Service Information Bulletin

SUBJECT	DATE
SPN 2791/FMI 7 – ALL YEARS	May 2013

Publication Number / Title	Platform	Section Title	Change
DDC-SVC-MAN-0084	DD Platform	SPN 2791/FMI 7	Deleted part numbers from step 4. Added graphics showing the different pull rods.

d140425

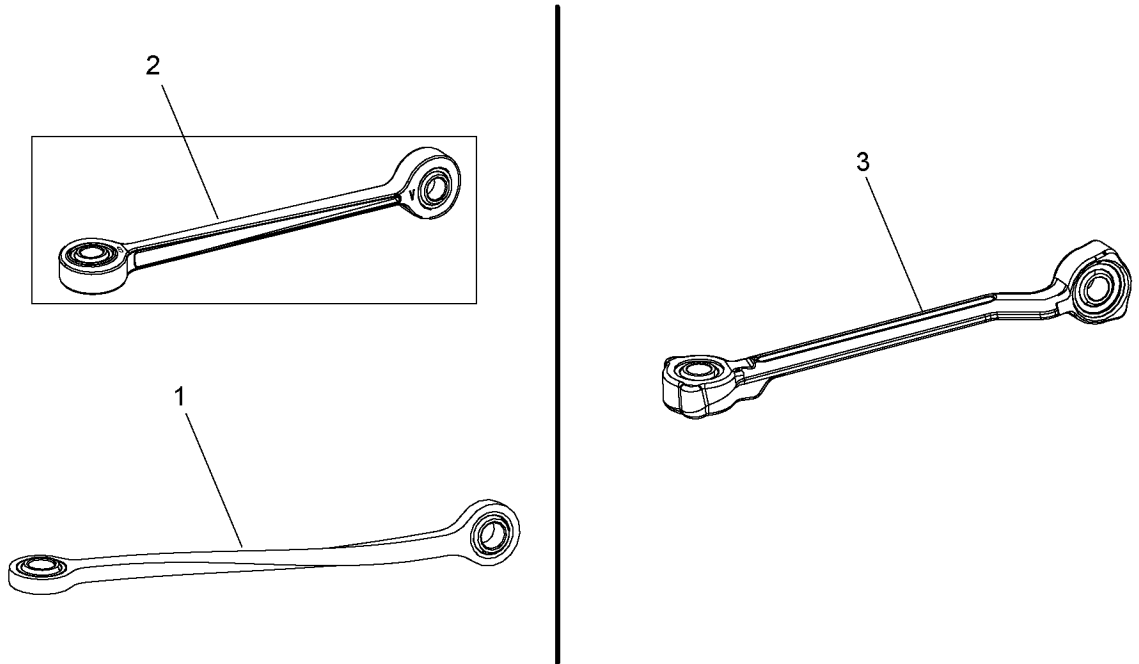
3. Turn the ignition OFF.
4. Disconnect the EGR valve actuator pull rod. Inspect the ball sockets on the pull rod for free movement.
 - a. If the ball sockets do not rotate/move freely or the rod is not the most recent part number, replace the EGR valve actuator pull rod.
For the DD13, Refer to section "Removal of the Exhaust Gas Recirculation Valve Actuator Pull Rod".
Before engine serial number HDE108907, the pull rods (1 and 2) were used. Beginning with engine serial number HDE108907, pull rod (3) is used. The pull rods are not interchangeable.

d140426

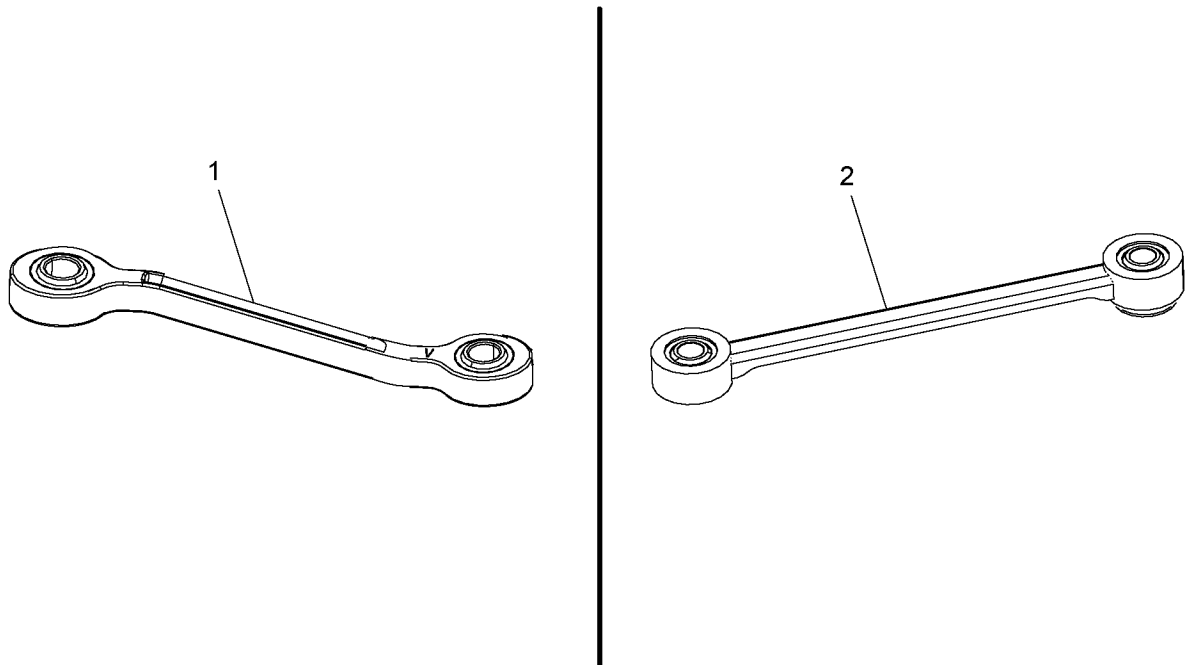
For the DD15 and DD16, Refer to section "Removal of the Exhaust Gas Recirculation Valve Actuator Pull Rod". Before engine serial number HDE172591, the pull rod (1) was used. Beginning with engine serial number HDE172591, pull rod (2) is used. The pull rods are not interchangeable.
